Access Compliance Report Public Rights-of-Way (Curb Ramps)

Main Street: **PIEDMONT_AVE** Cross Street: **ARGYLE_DR** Location: **N**

ADA ID: **RPAT211206105020** Ramp Type: **Type 1 - Perpendicular Diagonal** Initial Pass/Fail: **Pass** Overall Compliance: **No** Severity Score: **0**

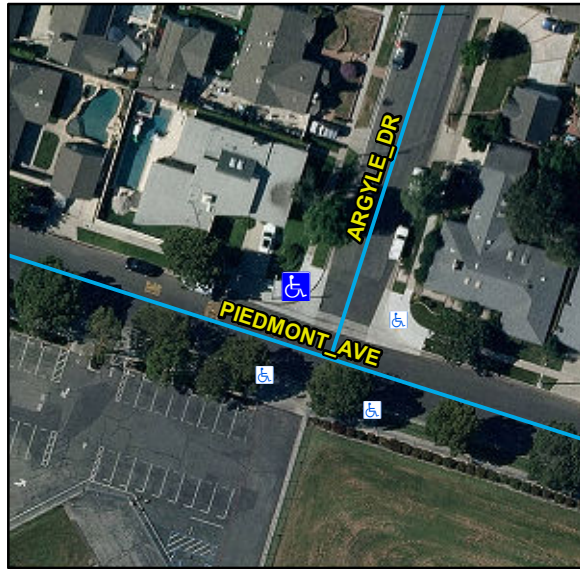
Compliance	Description	Data	Compliance	Description	Data
N/A	Ramp Length (in)	75	N/A	Flare Type LT	
Yes	Ramp Width (in)	49			Sloped
Yes	Ramp Run Slope (%)	6.8	N/A	Flare Slope LT (%)	6.3
Yes	Ramp Cross Slope (%)	0.8	N/A	Flare Traversable LT	No
N/A	Landing Present	Yes	N/A	Flare Type RT	
N/A	Landing Length (in)	48			Sloped
Yes	Landing Width (in)	50	N/A	Flare Slope RT (%)	7.6
Yes	Landing Run Slope (%)	1.1	N/A	Flare Traversable RT	No
Yes	Landing Cross Slope (%)	0.8	Yes	DWS Provided	Yes
N/A	Landing Movement Obstructed?	Yes	Yes	DWS Contrast	Yes
	Landing Movement Type	Curb	Yes	DWS Length (in)	36
N/A	Landing Shared	No	Yes	DWS Full Width	Yes
N/A	Clear Space	Yes	Yes	DWS Offset Left (in)	0
N/A	Clear Space To Crosswalk (in)	48	Yes	DWS Offset Right (in)	N/A
N/A	Marked Crosswalk 1	No	N/A	Marked Crosswalk 2	No
	Crossing 1 Direction	SW		Crossing 2 Direction	SE
	Marked Crosswalk 1 Width (in)	N/A		Marked Crosswalk 2 Width (in)	N/A

Remove & Replace Landing.

R304.2.1, STD 1115
